PLANNING COMMISSION STAFF REPORT
August 19th, 2025

Request: Residential Subdivision as a Planned Unit Development

Project: "Amare Vita"

File No.: 25-1-08

Figure 1

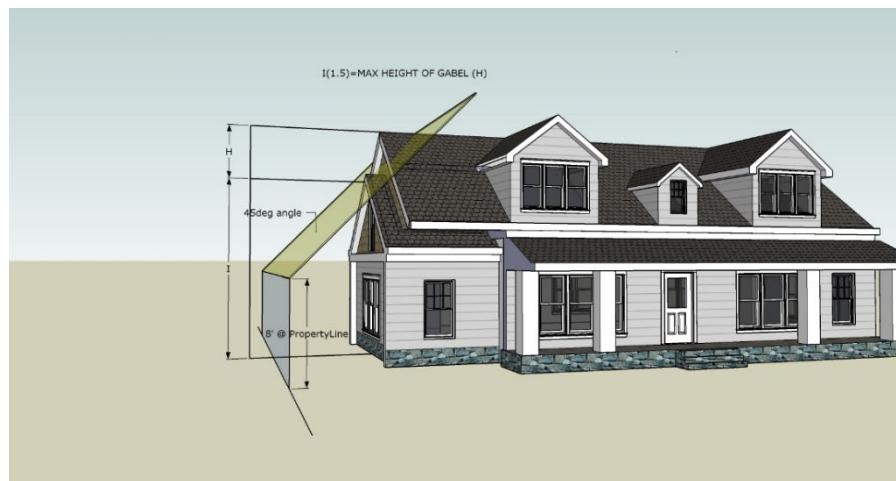
Building Height: PUD conditions may not alter allowable height. Compliance with §13.14.070 is required. As the proposed PUD creates individual lots that are smaller than the minimum required in the R-1-43 zone, building height would be limited to 35 feet. Structures would be required to meet graduated height requirements from each property line as shown in Figure 1.
